**Re: s75W MODIFICATION TO MAJOR PROJECT MP 09_0122
Bennelong Stormwater Drain Diversion
Sydney Opera House**

SOH - EASTERN SEA WALL Proposed Amendments to Stormwater Outlets

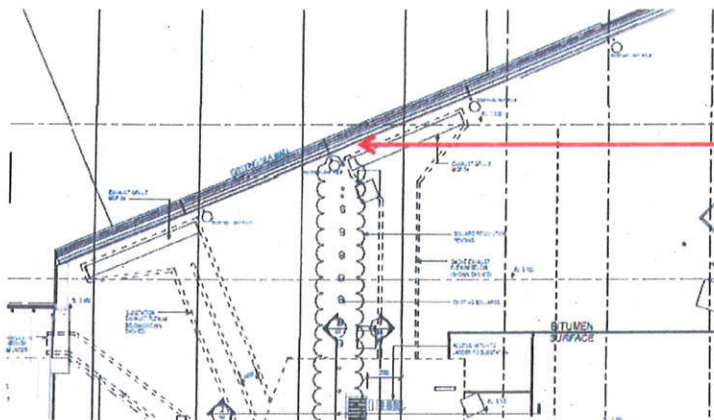
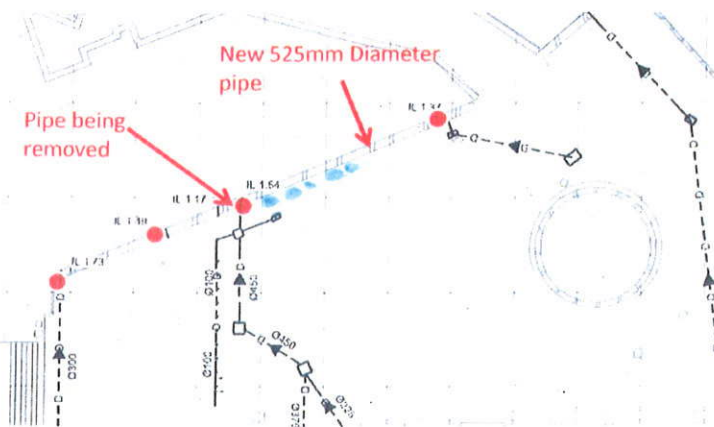
Existing S/water from
Car Park

New S/water Drain

New Obvert Level = 1.90
New Invert Level = 1.37
Pipe = 525mm diameter

New plenums under the asphalt paving disrupt a s/water outlet in this area. Proposed to remove; patch and replace with a new outlet as indicated below.

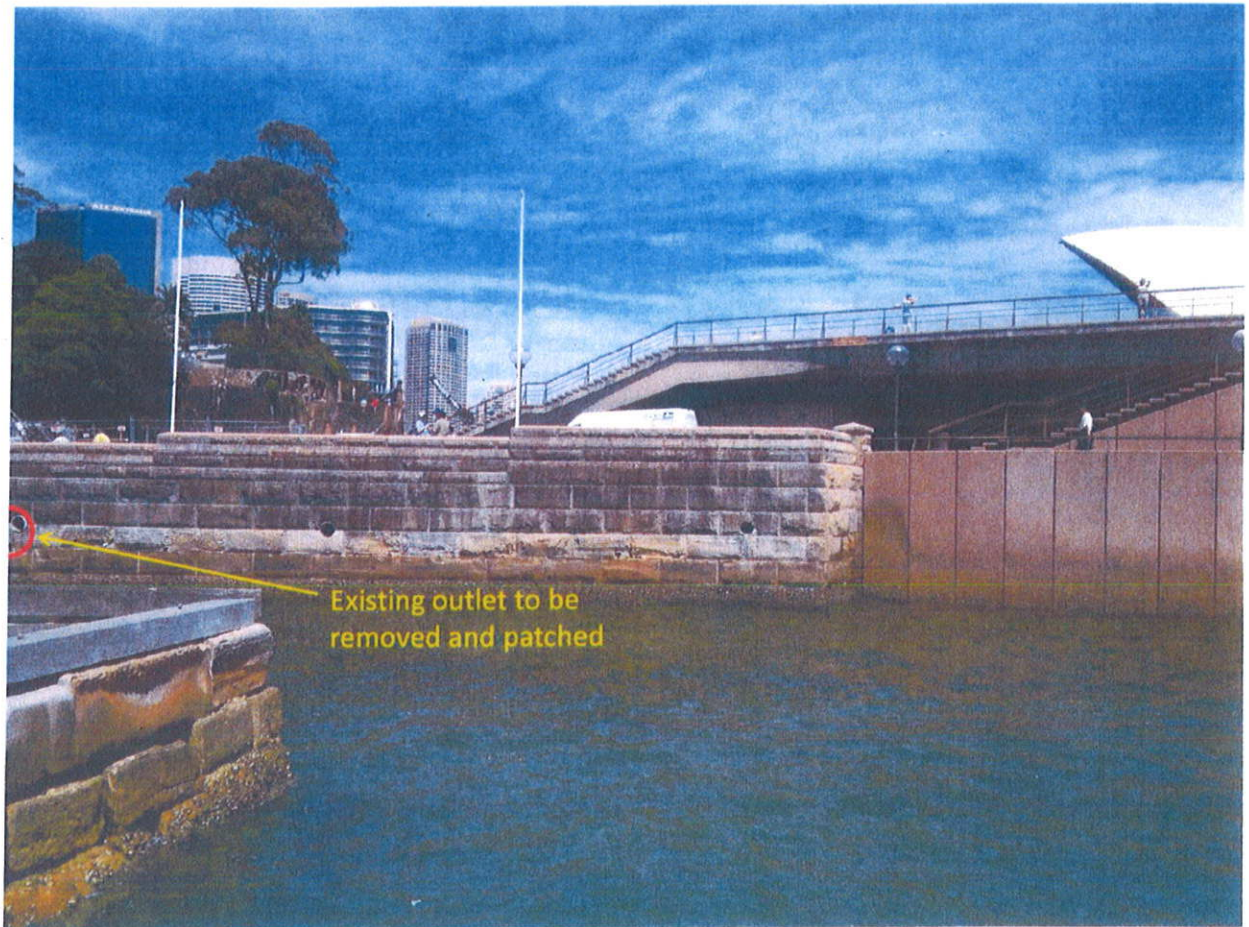
Existing outlet to be
removed and patched
